Re: Development of the former Trolley Barn Site Cranston, RI  
Traffic Study Peer Review  
Fuss & O'Neill Reference No. 20200078.T20

Fuss & O'Neill has conducted a review of the traffic study and associated Master Plan relating to the proposed development at 777 Cranston Street in Cranston, RI, also referred to as the former Trolley Barn site. The development consists of an AutoZone and warehouse, a car wash, a fast-food restaurant with a drive-thru window, and a convenience market/gas station.

F&O Markup prepared 6/10/2022  
 Overall recommendations to improve site circulation  
 Section 17.28.010 (B)(12) - Safe and Efficient Traffic Circulation

**SITE LAYOUT PLAN**  
**TROLLEY BARN PLAZA**  
 ASSESSOR'S PLAT 7 LOT 1  
 CRANSTON, RHODE ISLAND

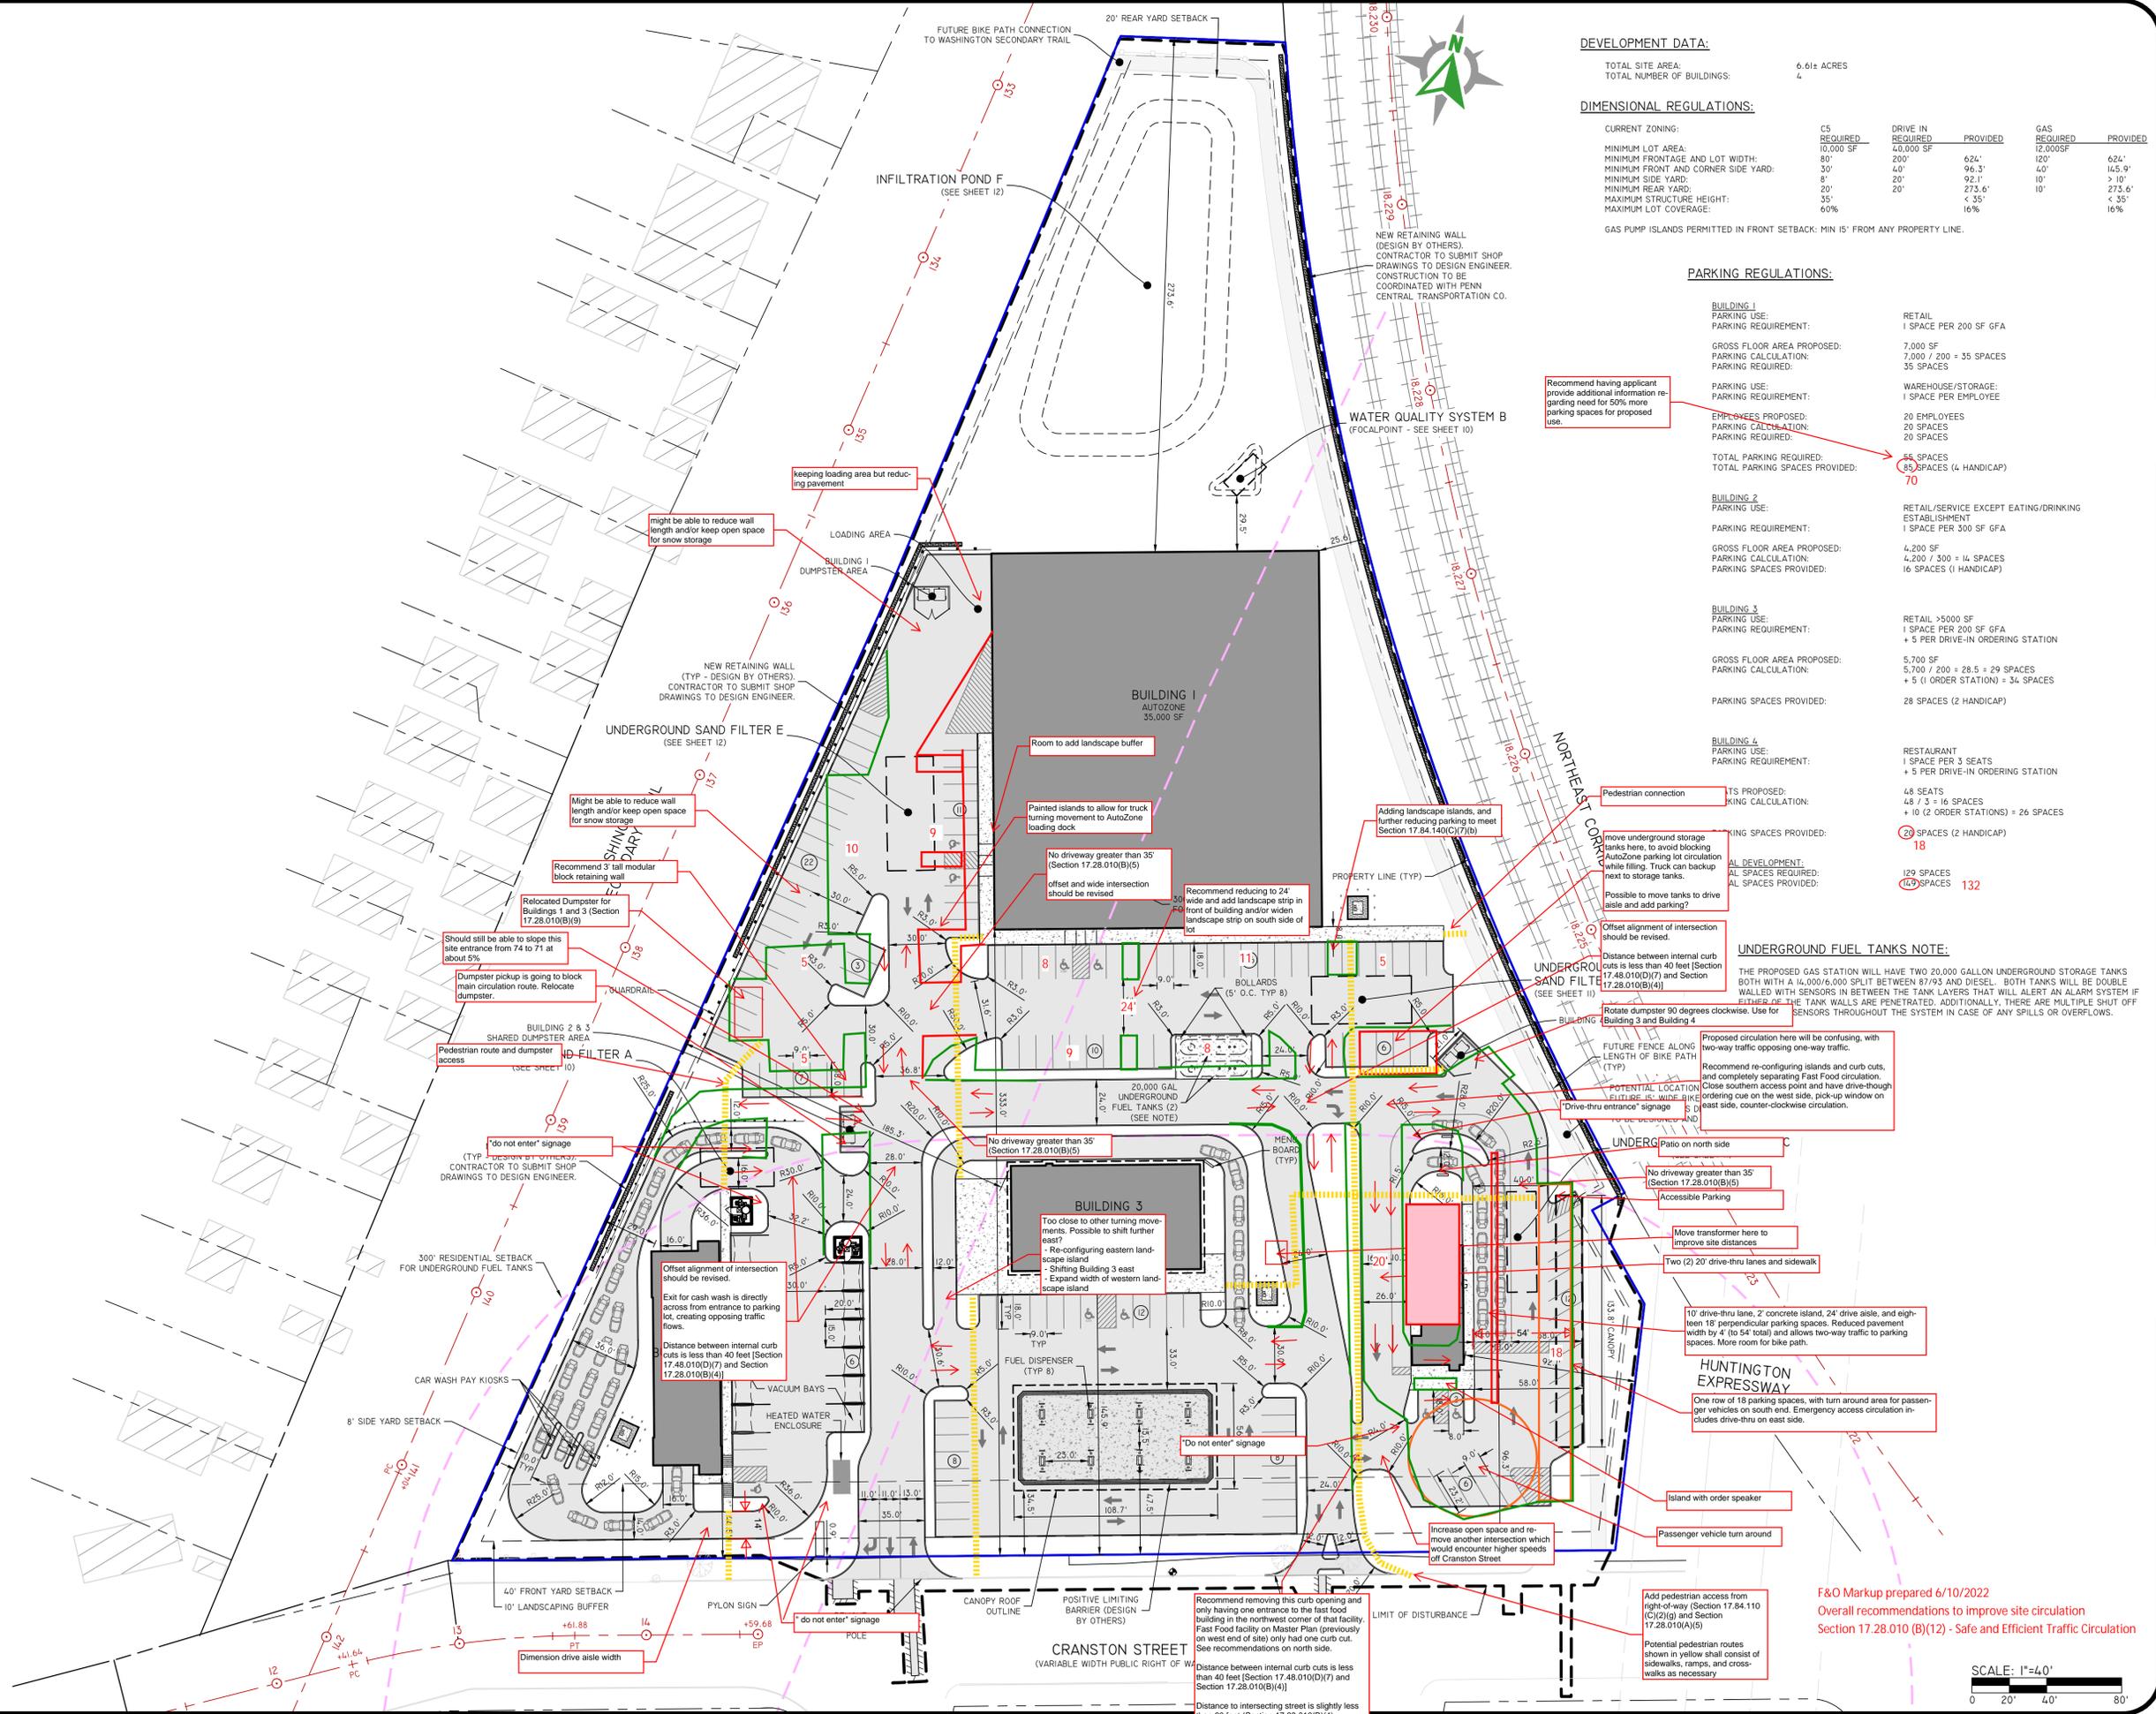
- a. Recommended pedestrian access routes are depicted in the sketch Site Circulation Markup, enclosed.
3. Section 17.28.010(B)(4) – The Fast Food driveway opening (measuring curb to curb) is less than 60 feet from Cranston Street.

- a. F&O understands that the City will be confirming the reference point for this measurement.
  - b. F&O recommends removing the second curb cut for the Fast Food use closest to Cranston Street. Master Plan only included one entrance for the Fast Food use.

4. Section 17.28.010(B)(4) and 17.48.010(D)(7) – There are multiple on-site driveway openings that are located within 40 feet of another driveway opening (measuring curb to curb). These proposed alignments should be revised to create clear 4-way intersections where possible.

5. Section 17.28.010(B)(5) – There are multiple locations where the proposed driveway width is greater than 35 feet. These locations should be revised, or a waiver shall be requested.

- a. Recommended revisions are depicted in the sketch Site Circulation Markup, enclosed.

6. Section 17.28.010(B)(9) – Dumpster for Building Nos. 2 & 3 is located on the main traffic circulation drive aisle on site. This dumpster should be relocated so that trash pickup wont block traffic flow for the other buildings.
  - a. A recommend location to the northwest is proposed and depicted in the sketch Site Circulation Markup, enclosed.

7. Section 17.28.010(B)(12) and 17.48.060(D) and 17.84.150(A)(2) – The majority of the recommended layout revisions depicted in the enclosed Site Circulation Markup sketch are to improve the on-site vehicle and pedestrian safety.

**CONCRETE DUMPSTER PAD WITH BOLLARDS AND FENCE**  
NOT TO SCALE

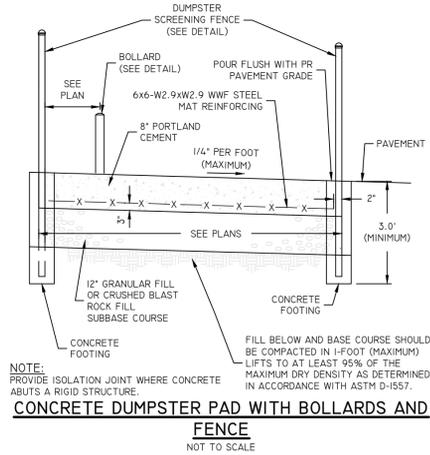
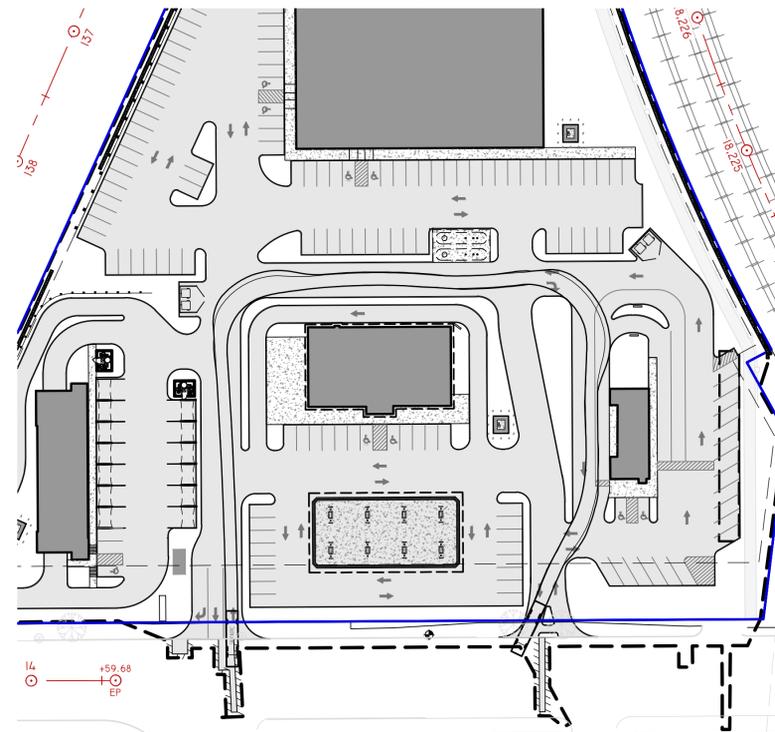
F&O Markup prepared 6/10/2022  
Overall recommendations to improve site circulation  
Section 17.28.010 (B)(12) - Safe and Efficient Traffic Circulation
